Access Compliance Report Public Rights-of-Way (Curb Ramps)

Main Street: ST_CLOUD_DR Cross Street: DRUID_LN Location: SE

ADA ID: RPRK211206142302 Ramp Type: Type 4 - Parallel Initial Pass/Fail: Fail Overall Compliance: No Severity Score: 45

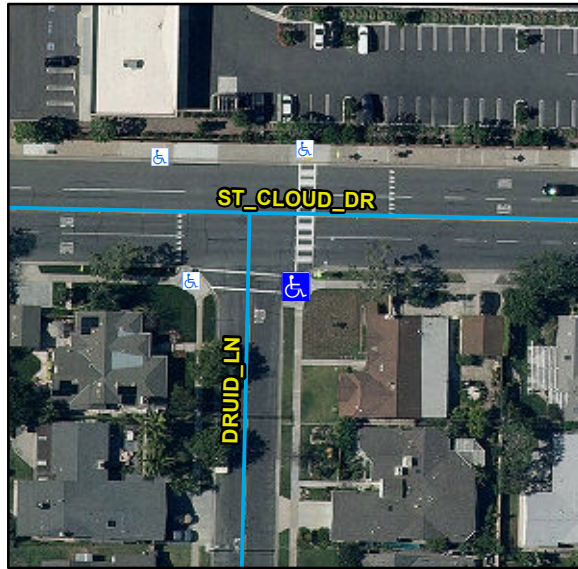
R304.3.2, R304.5.3, STD 1115

Remove & Replace Curb Ramp With Two New Directional Ramps or Equivalent.
